REMARKS

The application and claims have been amended to make it more apparent that the claims cover allowable subject matter and to overcome the objections and rejections under Sections 112 and 103. It is believed that the amended claims are in allowable form. The newly submitted claims correspond to the previous claims with more particular description of the features beginning on pages 3, 8 and 15 of the specification.

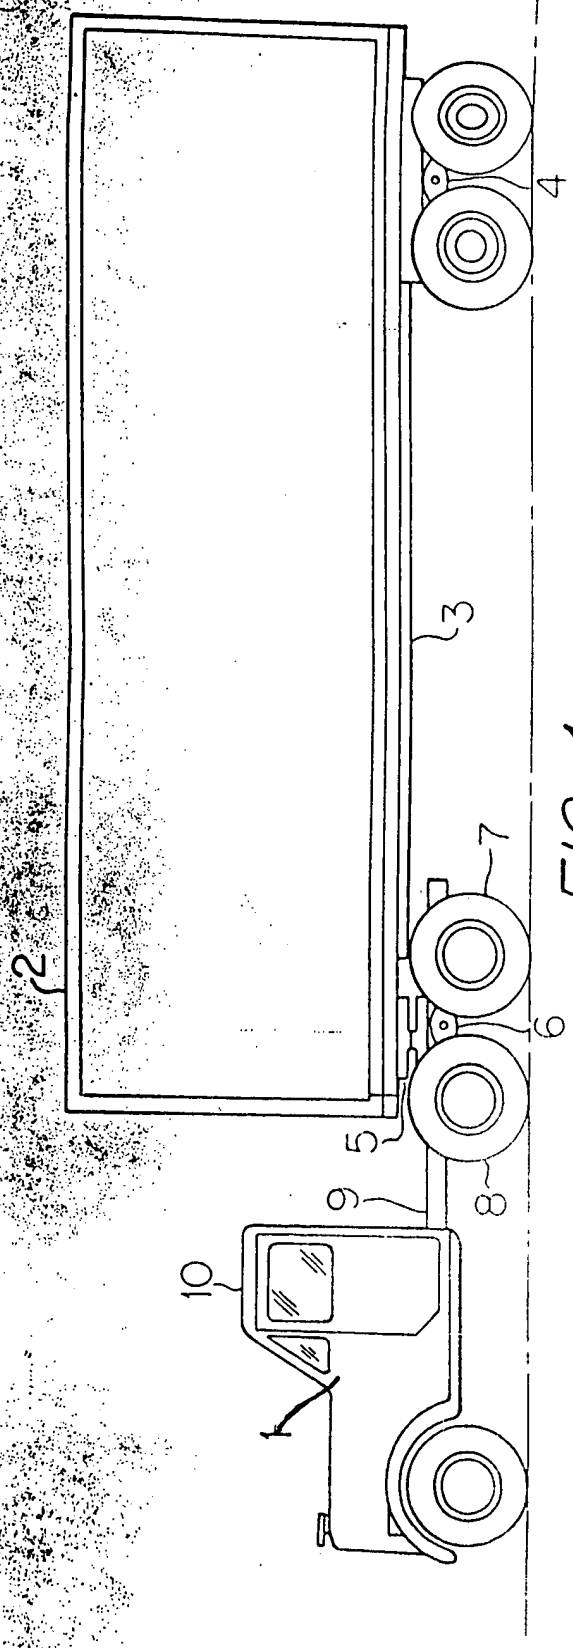
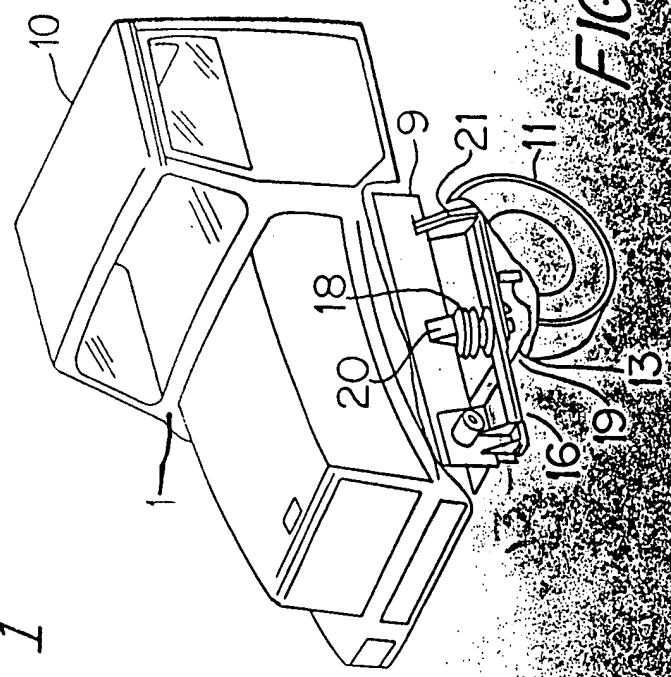
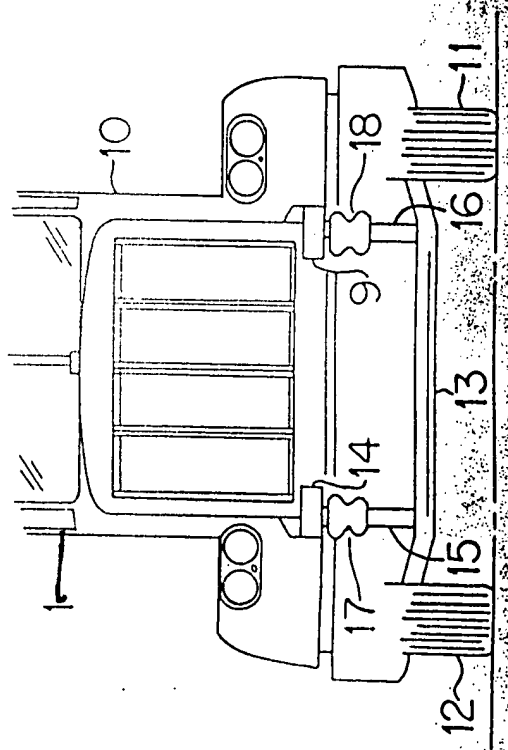
The needed changes to the specification and drawings have been made. Indication of the needed changes by the Examiner is appreciated. Apparently, some of the difficulties may be due to the quality of the copy of the informal drawings. The nature of the restriction or orifice and its location and function is discussed in detail in the specification beginning on pages 3, 8 and 15.

Proposed corrections for the drawing are shown in red on the copy of the drawing submitted herewith. The numeral "1" refers to the truck in general. The reference in the Office Action to numeral "31" is not clear; no reference to numeral "31" is found on page 8 of the specification; numeral "31" is shown in Figure 5. Numeral "31" in Figure 5 refers to one of several possible embodiments of the springs which can be used on the type of vehicle discussed in the specification. Where possible, the corrections have also been set forth above in the amendment.
